SERVICE BULLETIN

Affected Equipment: YPAL Model F, 50 - 65 TON

Subject: Ground Wire on Supply, Exhaust and/or Return Fan Motors

Issue Date: 4-25-2011

FIGURE 1 - INCORRECT SUPPLY FAN GROUNDING

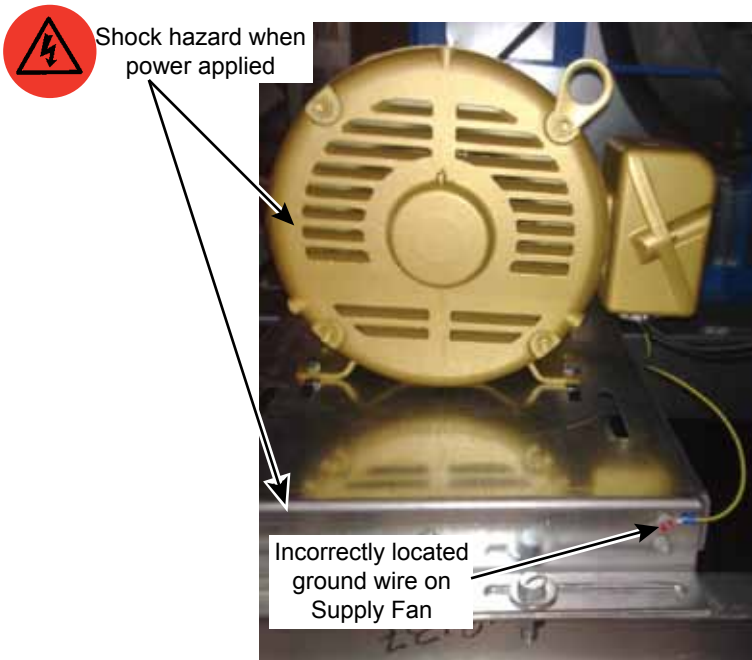
The ground wire from the motor is connected to the isolated section of the motor(s) on YPAL 50-65 Model F R410A units (see Figure 1). This presents a possible shock hazard because the motor may not have a proper connection to the main ground of the unit. This could occur on any or all of the motors in the unit (Supply, Return, and/or Exhaust).

DO NOT touch motor or railing with power applied, utilize standard lockout tagout procedures. See Figure 2 and 3 for correct fan grounding. Remove the ground wire connection from the isolated section of the motor and relocate the wire to a spot on the unit frame or support bracket (see Figure 3). If the wire length is not adequate use the materials above to replace the wire and attach as indicated.
